RE: 1753 - 1805 Gum Street

I reviewed the drawings, visited the site, and prepared a preliminary review of the project last August. My comments and recommendations on the revised design are summarized below.

CURRENT GUM STREET ELEVATION

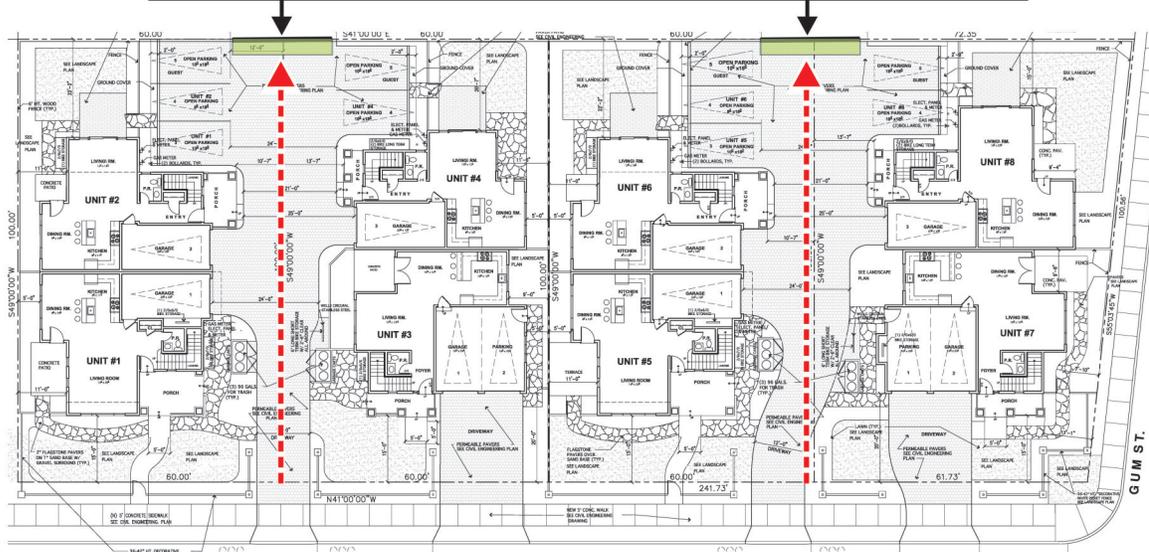
The project has been revised from the previous design that I reviewed in August. The number of units has been reduced from nine to eight, and the complex should have a slightly more open, single family feel along the Gum Street frontage (See streetscape comparison of the current and previous projects below). The homes are a bit wider than the original proposal, but because of the second floor setbacks should be compatible with the other homes in the neighborhood.

True Divided Lite Window

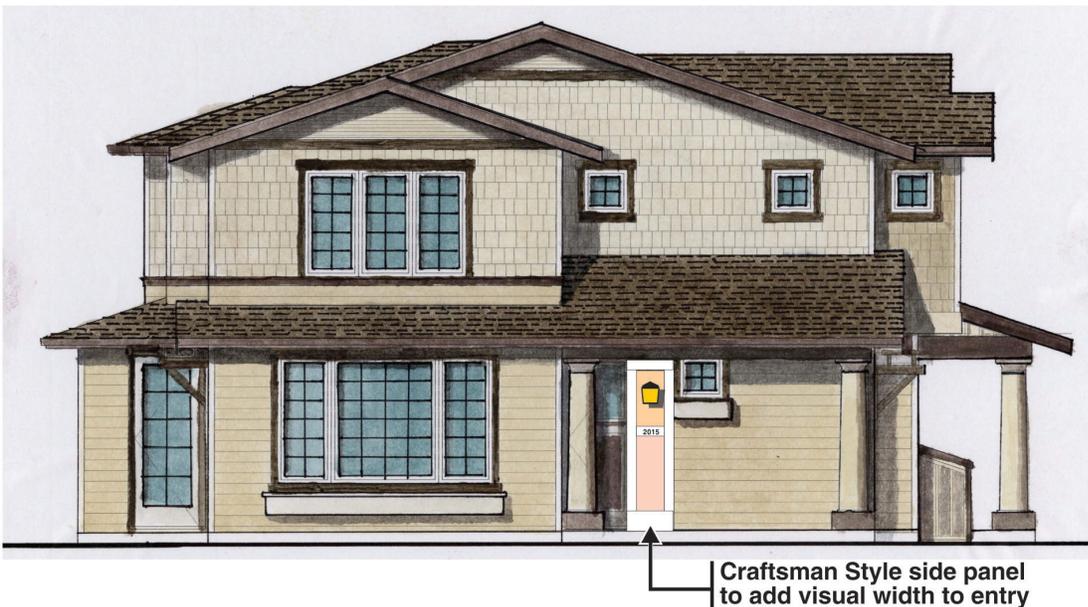
- The materials board call out “5/8” flat grids” for the windows and outside doors. This is a relative low quality approach to window grids - especially for homes that are designed in the Craftsman Style.

Recommendation: Utilize true divided lite or simulated divided lite windows with substantial depth to the window pane dividers. Examples are shown below.
